Addendum No. 4 **Issued: November 17, 2026**

Project Name:	Pottsgrove High School Facilities & Athletic Improvements ICS Project No. S25009
Project Owner:	Pottsgrove School District 1301 Kauffman Road Pottstown, PA 19464
Construction Manager:	ICS – Scott Kennedy 1400 N. Providence Road Building 2, Suite 4025 Media, PA 19063

SYSTEMS PLAN - HOME SIDE CONCESSIONS AND RESTROOM BUILDING

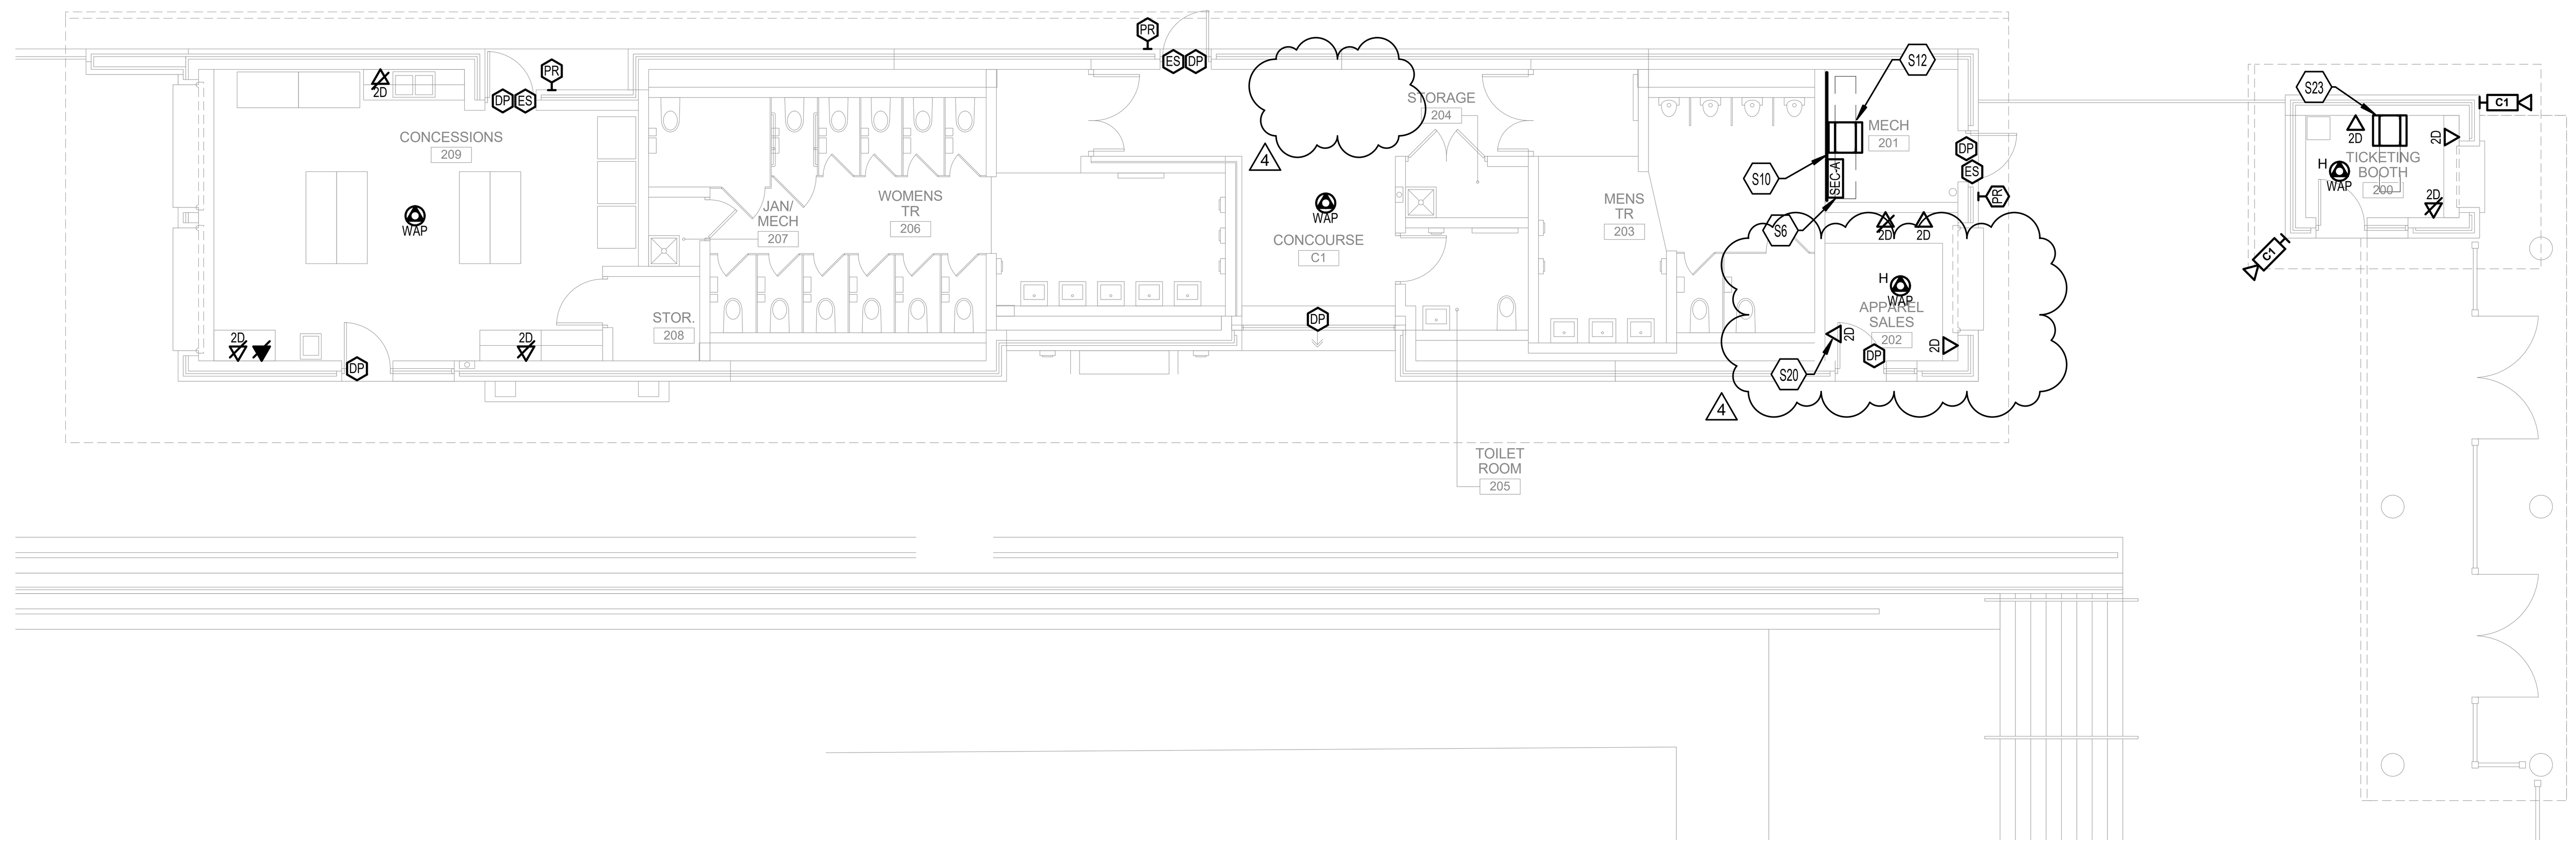
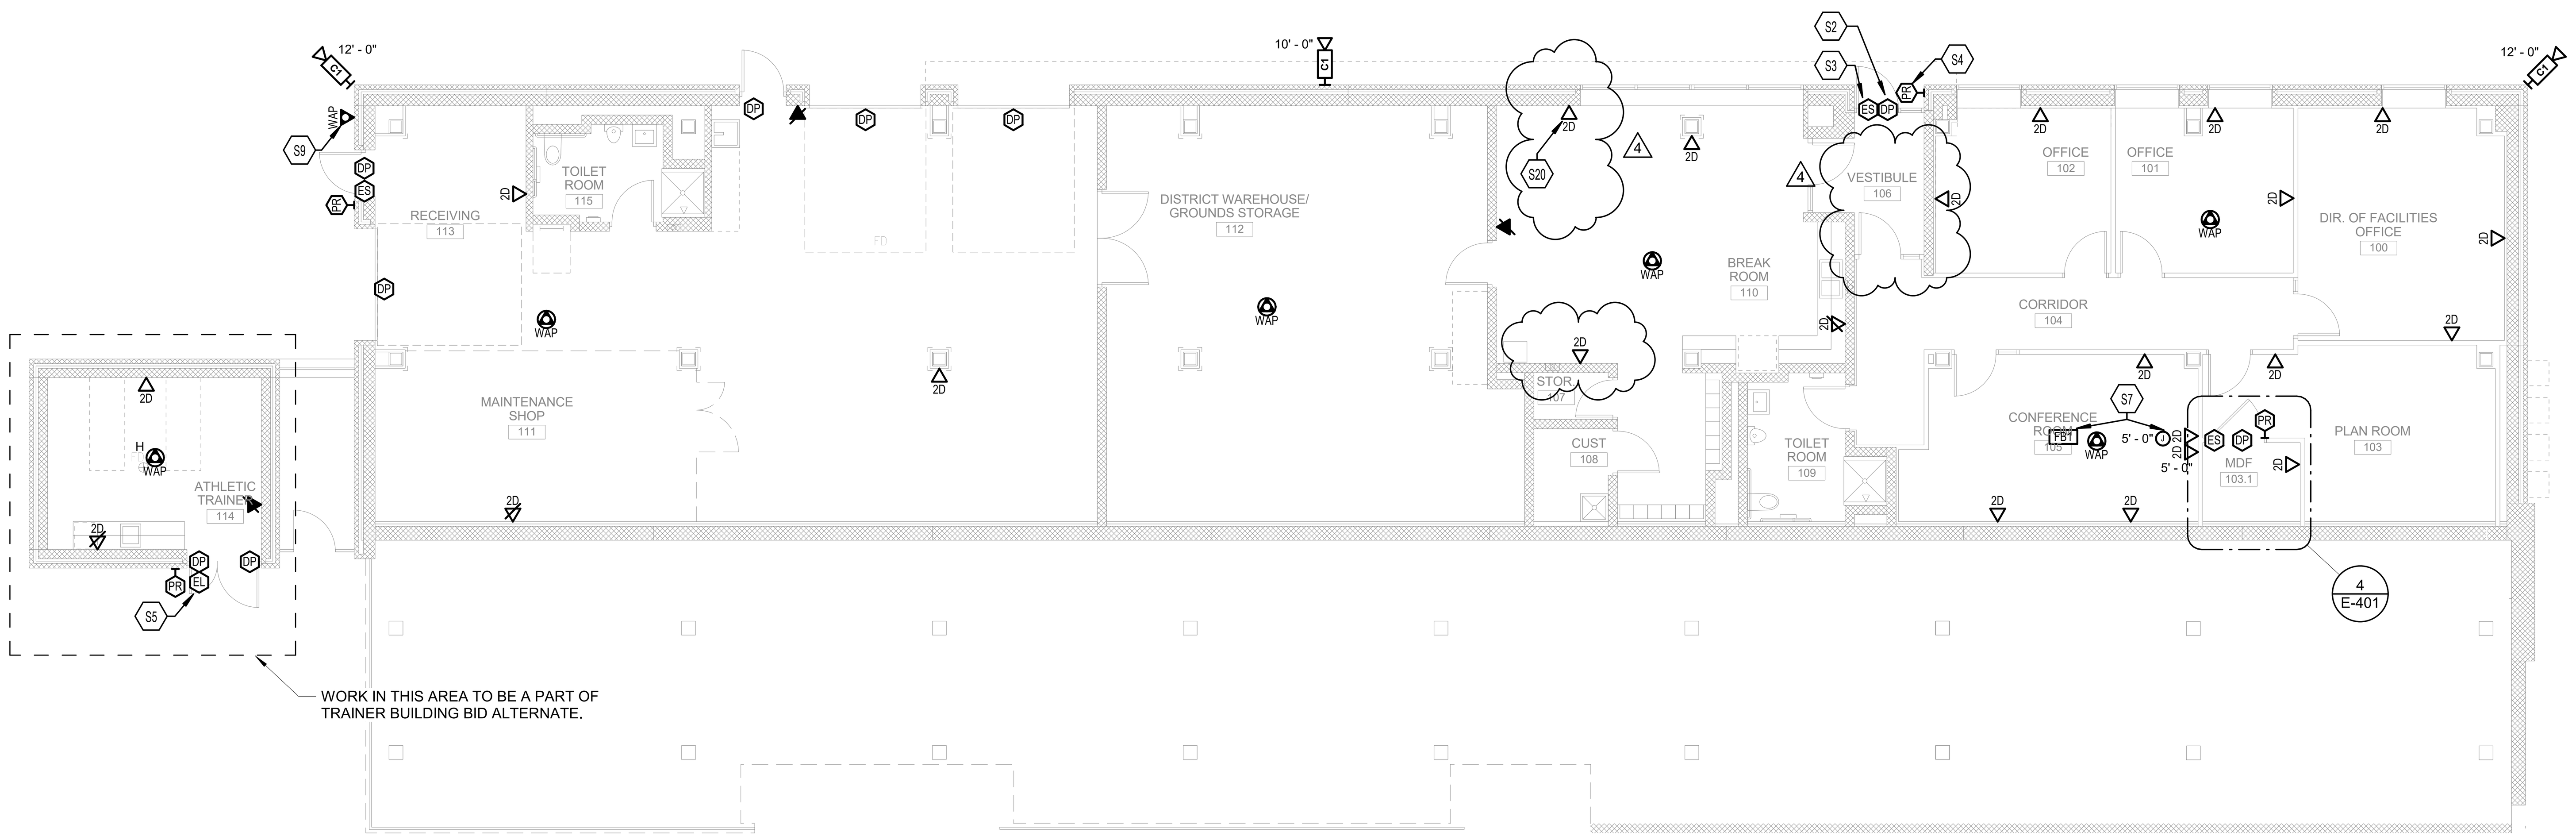
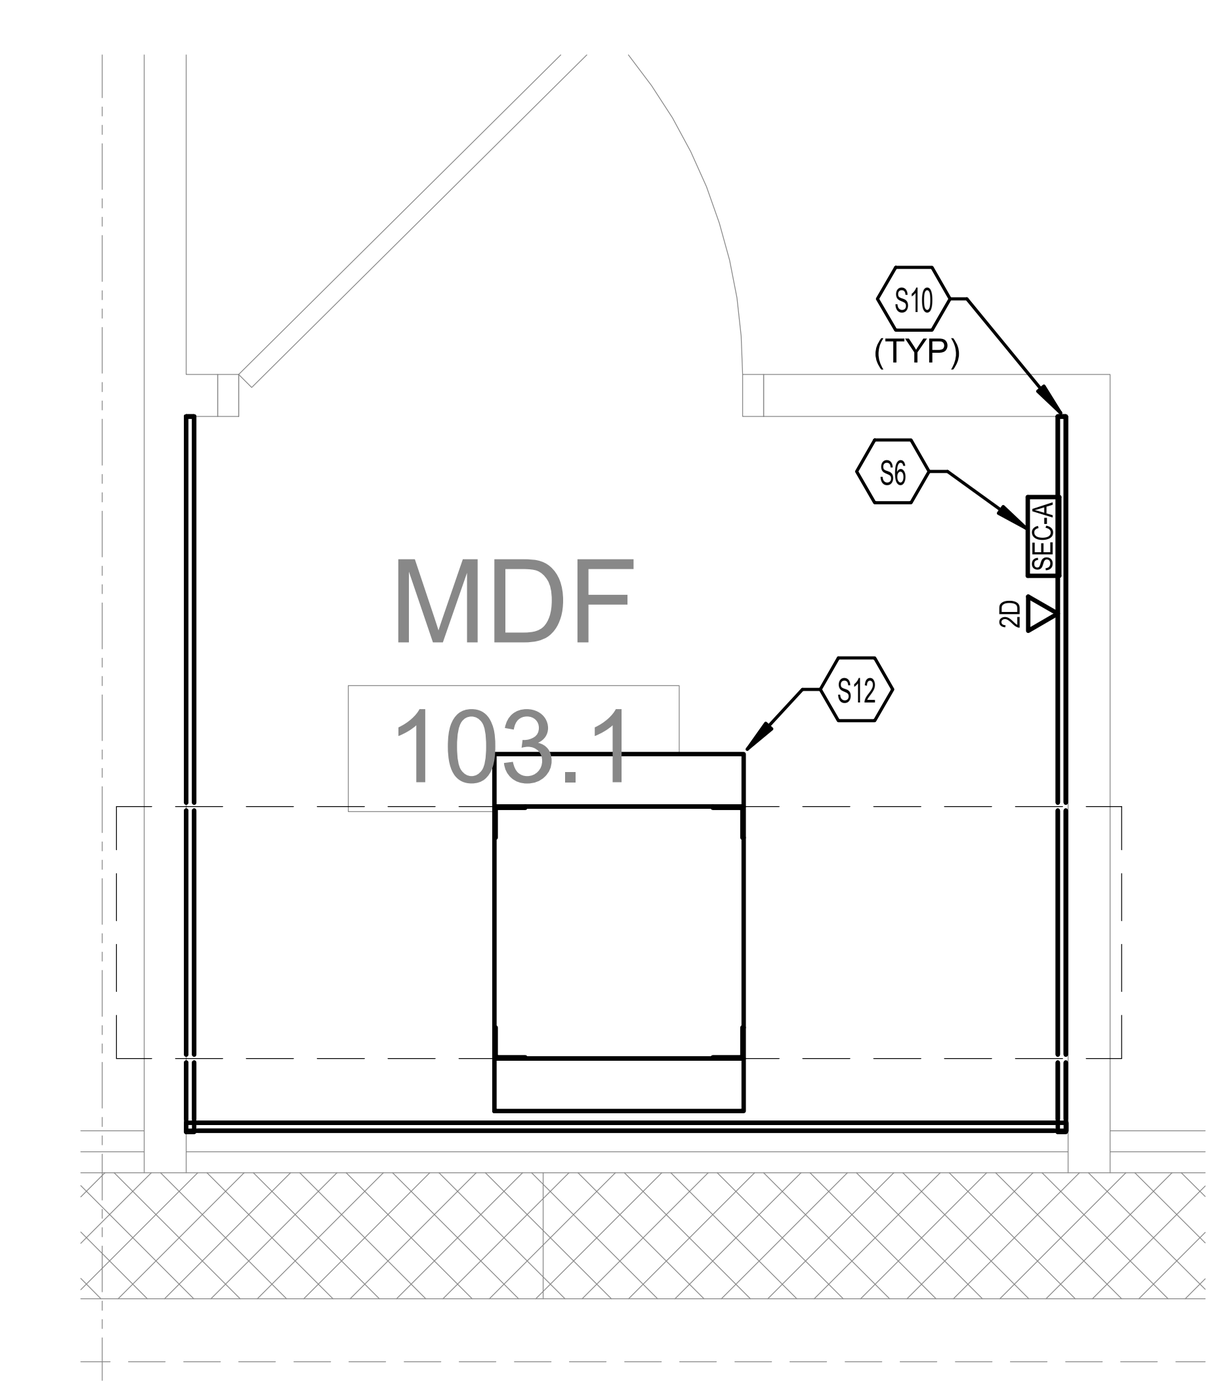
5.32 Drawing Sheet E-401 ”SYSTEMS PLAN -HOME SIDE PAVILLION” (Reference attached Reissued Drawing):

- Adjusted data drops to match FACP location.
- Adjusted data drop location associated with Home Side FACPs.
- Adjusted data drop locations in outdoor press platforms on Press box. Added requirement for some drops to be weatherproof type.

1 ONE-LINE DIAGRAM

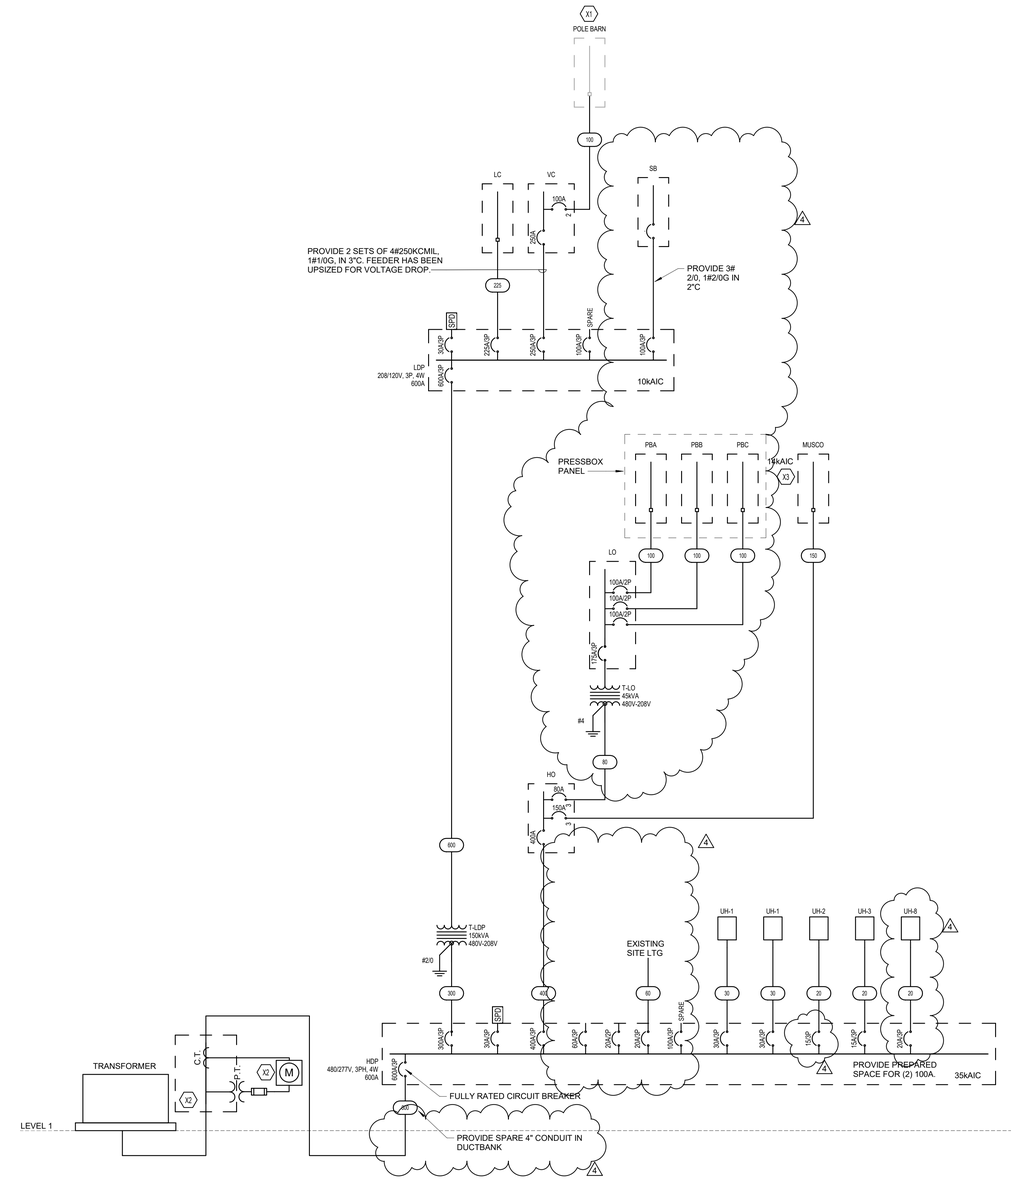
5.34 Drawing Sheet E-600 “ONE-LINE DIAGRAM” (Reference attached Reissued Drawing):
- Updated scoreboard power panel feed requirements and origination.
- Added Scoreboard Panel SB Panel Schedule.
- Added backfeed for existing site lighting to one-line diagram.
- Added requirement for spare 4” conduit to be routed with secondary building conductors.
- Updated oneline per pressbox changes to include additional feeders.

1 E-800 SYSTEMS ONE-LINE DIAGRAM
NOT TO SCALE

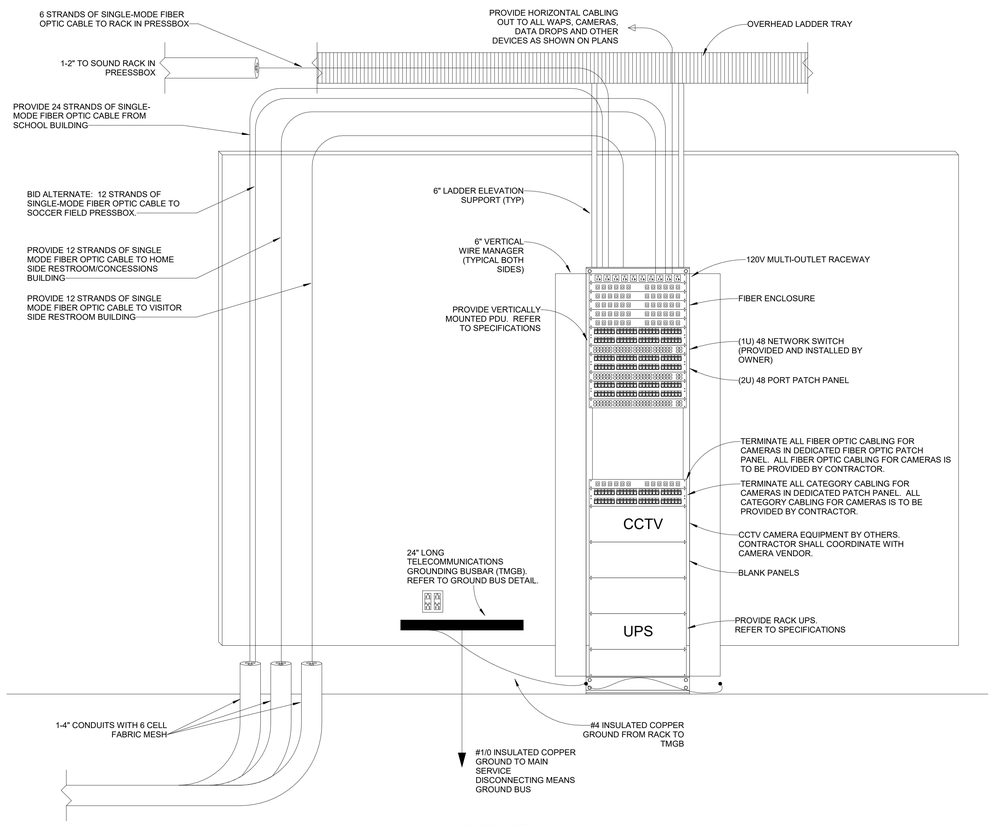
5.36 Drawing Sheet E-800 “SYSTEMS ONE-LINE DIAGRAM” (Reference attached Reissued Drawing):
- Added reference to baseball field fiber optic feed. Feed was previously shown only on site plan.
- Clarified fiber optic feeds to be 12 strand, not 6 strand.

6.9 **Question:** EU-101: Tagged note U19 calls for 12 strand FO. E-800, telecom riser home side concessions shows 6 strand FO. Which type of cable is required for this run? EU-101: Tagged note U34 calls for 12 strand FO. E-800, telecom riser visitor restroom IDF shows 6 strand FO. Which type of cable is required for this run?

Response: Provide 12 strand fiber optic cabling. See Drawing #

1 SITE ELECTRICAL DEMOLITION PLAN

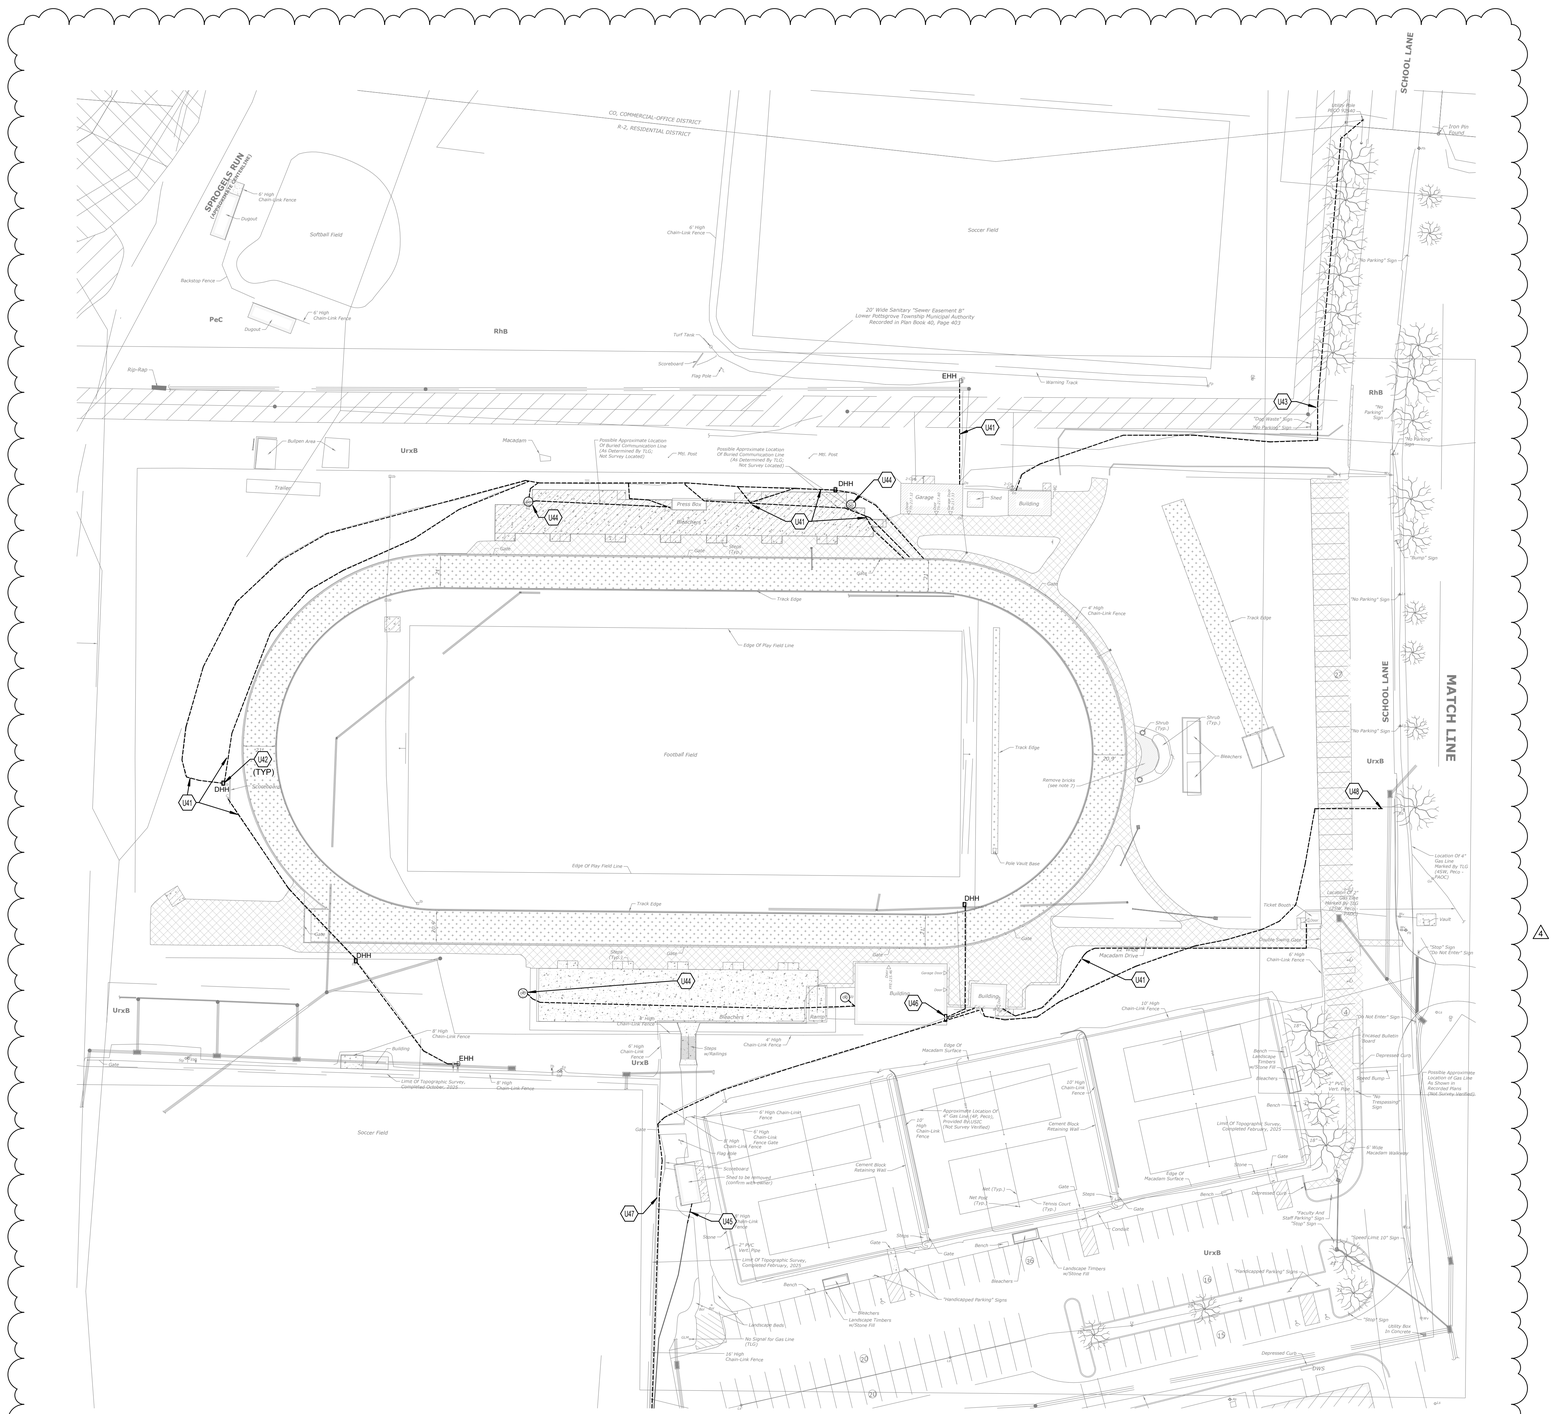
5.25 **ADDED** Drawing Sheet EU-100 “ELECTRICAL SITE DEMOLITION PLAN” which shows Electrical Contractor responsibilities for demolition work.
